MANDATORY BULLETIN

Number: ZB SD4-04-2013

Name/Subject: Location of the sensing of the static pressure inside the rear of the fuselage

Models affected: Viper SD-4 aircraft with serial numbers:
003, 006, from 010 to 012 inclusive, 014, 015, from 017 to 019 inclusive,
022, 023, 025, 029

1. Disconnection of tubes from static pressure ports on the sides of the fuselage.

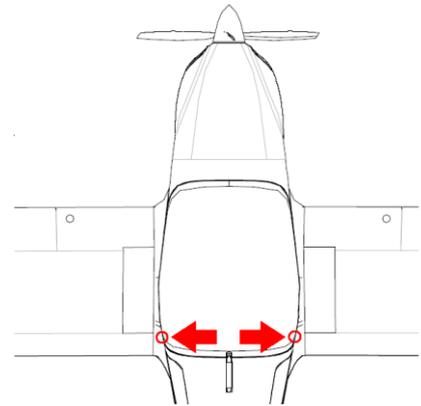
The original static pressure ports are located symmetrically on the sides of the fuselage, below the cockpit windows, as it is shown in the picture on the right.

The static pressure ports have a round shape and are riveted to the insides of the side fuselage skins in the upper part of the baggage area.

The static pressure ports are connected to plastic tubes $\text{Ø}6 \times 1$ mm, leading to the flight instruments located on the instrument panel. The tubes are secured on the static pressure ports by locking clips.

With the help of pliers remove the locking clips and disconnect both tubes from the static pressure ports.

Blind the tube on the right side of the cockpit with a suitable plug, e.g. silicon sealant, a peg or a screwed-in screw, sealed with suitable glue or sealant.

Then push the tube into the opening in the reinforcement piece from which it sticks out, so that it sticks out just about 5 cm and does not pose as an obstacle in the baggage area.

Fit a suitable lengthening tube with the inner diameter 5 to 6 mm and about 25 cm long on the tube on the left side.

Insert the free end of the lengthening tube into the small hole in the upper corner of the baggage area at the side fuselage skin, so that the tube is straightened along the side fuselage skin.
